A d d e n d u m

Iowa Department of Transportation
Office of Contracts

Date of Letting: December 20, 2011
Date of Addendum: December 13, 2011

B.O.	Proposal ID	Proposal Work Type	County	Project Number	Addendum
007	37-0042-038	BRIDGE NEW - PPCB	GREENE	HDP-004-2(38)--71-37	20DEC007.A02

Sheet Number 64:

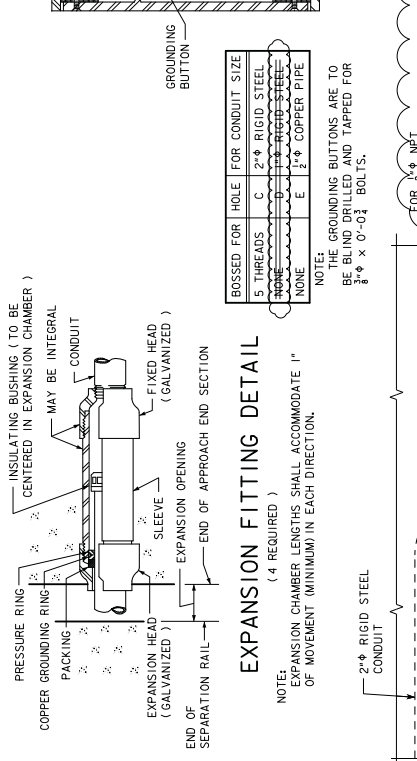
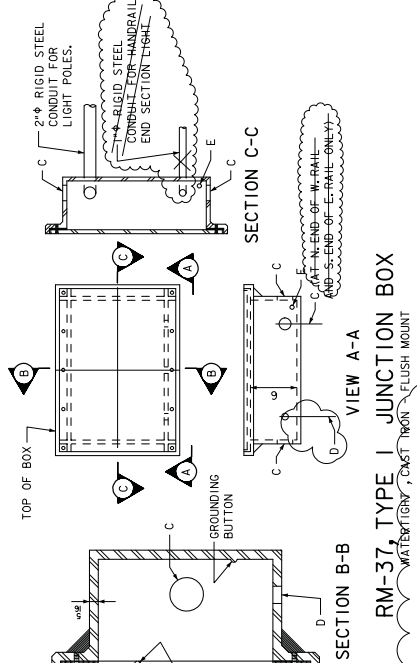
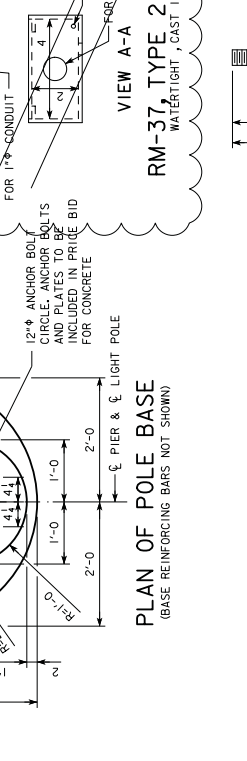
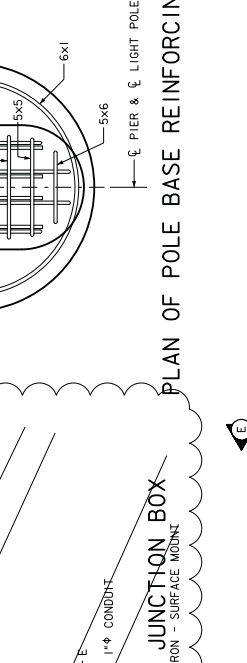
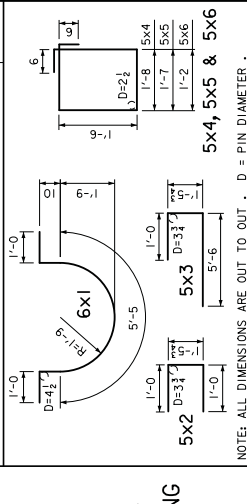
Replace Sheet Number 64 with the attached Sheet Number 64.
